Safety Recall: Civic Fuel Fill Hose Clamps

Safety Recall: Civic Fuel Hose Clamps

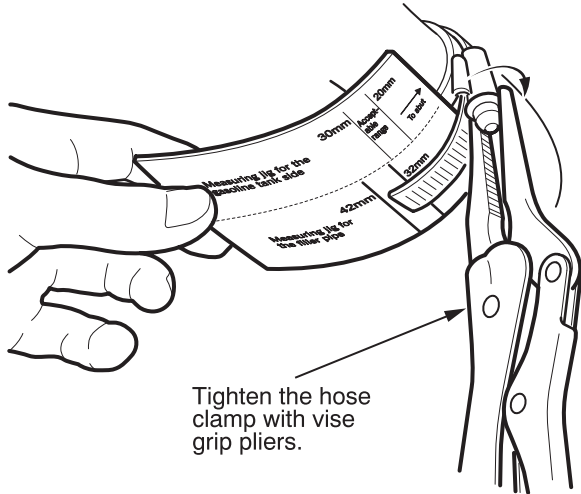
1. Raise the vehicle on a hoist.
2. Remove the fuel fill pipe cover.
3. Insert the card under the tail of the hose clamp that is around the fuel fill pipe.

- If the tail of the hose clamp reaches the acceptable range on the card (32 to 42 mm) or extends past the range, the hose clamp is properly tightened. Go to step 5.
- If the tail of the hose clamp does not reach the acceptable range, go to step 4.

- Use a pair of vise grip pliers to tighten the hose clamp until the end of the tail reaches the acceptable range.

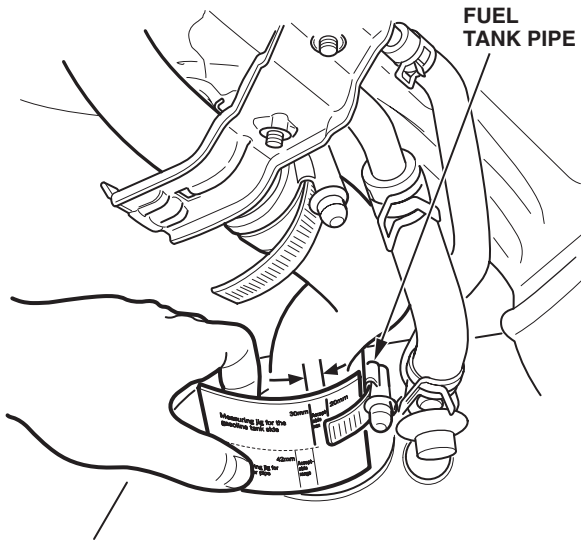
- Insert the supplied card under the tail of the hose clamp that is around the fuel tank pipe.

- If the tail of the hose clamp reaches the acceptable range on the card (20 to 30 mm) or extends past the range, the hose clamp is properly tightened. Go to step 7.
 - If the tail of the hose clamp does not reach the acceptable range, go to step 6.
- Use a pair of vise grip pliers to tighten the hose clamp until the end of the tail reaches the acceptable range.
 - Reinstall the fuel fill pipe cover.
 - Lower the vehicle.
 - Center-punch a completion mark above the last character of the engine compartment VIN.
